Reference: 200379.02FA

LETTER OF RESPONSE REGARDING MIXED USE DEVELOPMENT AT 4 - 18 NORTHWOOD ROAD & 274 - 274A LONGUEVILLE ROAD, LANE COVE

Reference is made to your request to provide supplementary information to assist Council in determining the development application for DA113/2020. The comments made by Council relevant to traffic and parking are outlined within Council's Traffic Engineers *Memorandum – Referral Request and Response* dated 23rd September 2020 and in an email dated 23rd September 2020. A response has been provided to each of the comments made by Council (shown *italicised*), with the amended plans shown in **Annexure A** for reference.

FIGURE 1: POISSON DISTRIBUTION

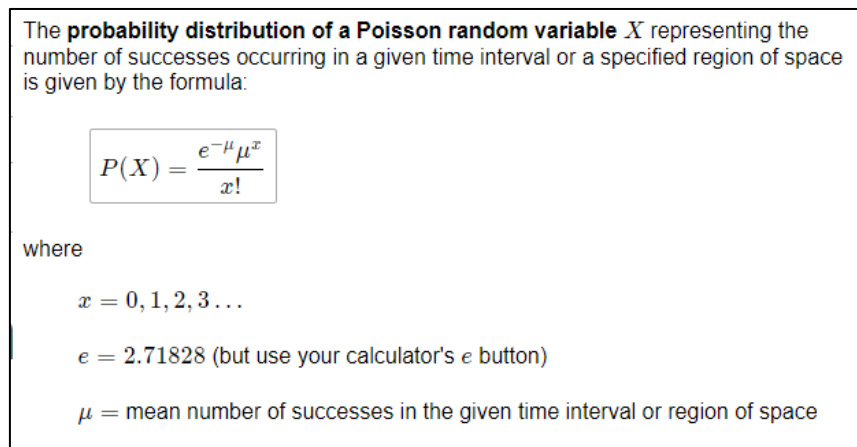
A safety and functionality report for the traffic signals for the one-way ramp has been asked for

MTE Response: A queuing assessment has been undertaken to determine the queue impacts as a result of the single lane ramp. The following are relevant to note:

As noted above, staff development traffic is highly tidal as such to determine any sort of queuing that may occur due to the single lane ramp, the probability of a vehicle exiting the Level 1 Basement and entering the Level 1 Basement needs to be determined. Outside this conflict there is no conflict between opposing vehicle streams, such that there would be no vehicle queues.

To determine the conflict of opposing vehicle streams, reference is made to the Poisson Distribution as shown in **Figure 1** below. Which allows the determination of an event occurring over a given time interval or a specified region of space, which in our case is the time it would take a vehicle to travel along the one-way section of ramp.

The above determination of conflict between opposing vehicle streams has been undertaken based upon the following considerations:

- A distance of 50m between passing opportunities (i.e. the distance where access is restricted to one vehicle);
- Based upon the 50m and a travel speed of 5km/h (highly conservative), the resulting time it takes to travel the 50m distance is 36 seconds;
- Adopting an addition factor of safety of 4 seconds for the light to turn from red to green or vice versa results in a travel time of 40 seconds;
- Inbound traffic of 40 vehicle trips;
- Outbound traffic of 4 vehicle trips.

Adopting the above time of conflict, vehicle trips and direction, the probability of conflict along the 50m length of assessed area is 3.52%. As shown, this is a low chance of conflict between vehicle streams, resulting in one conflict occurring every 28 AM peak hour period. When that conflict does occur, 92% of the time there would only be one vehicle waiting or 8% of the time there would be more than one vehicle waiting for the inbound traffic stream (40 vehicle trips). It should be noted that the 99th percentile queue is two (2) vehicles.
